**Display**

Model: **BKM-41HD, BKM-42HD**

Subject: **NOISE IN 100% COLOR BAR SIGNAL IN HIGH TEMPERATURE ENVIRONMENT**

**Figure 1**

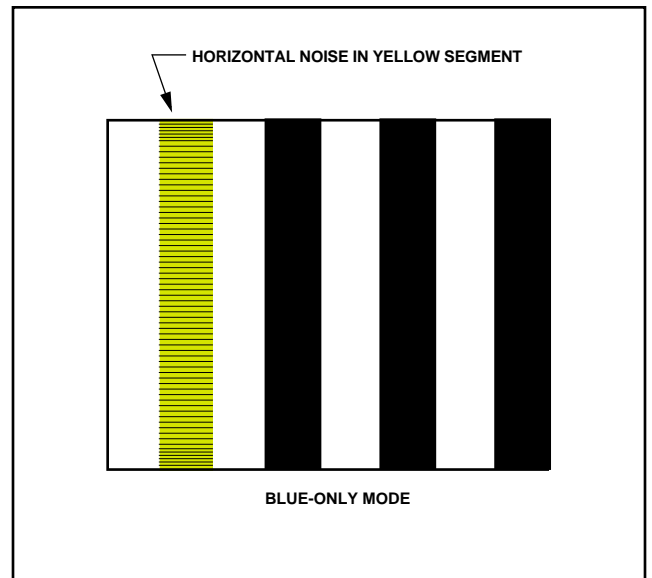
If unit is used in a high temperature environment, noise may appear in the yellow segment of the 100% color bar signal. (See Figure 1.) Noise is easier to view when the monitor is in Blue-Only mode. To correct the symptom, perform the following modification procedure.

1. Remove conductive tape from four locations on unit.
2. Remove unit cover.
3. Remove PWB shield from solder side of board by removing four screws.
4. Replace former R33 (0Ω) with new 100Ω (1-216-025-11) resistor (zone D-6).
5. Reinstall PWB shield.
6. Reinstall unit cover.
7. Reapply new conductive tape.
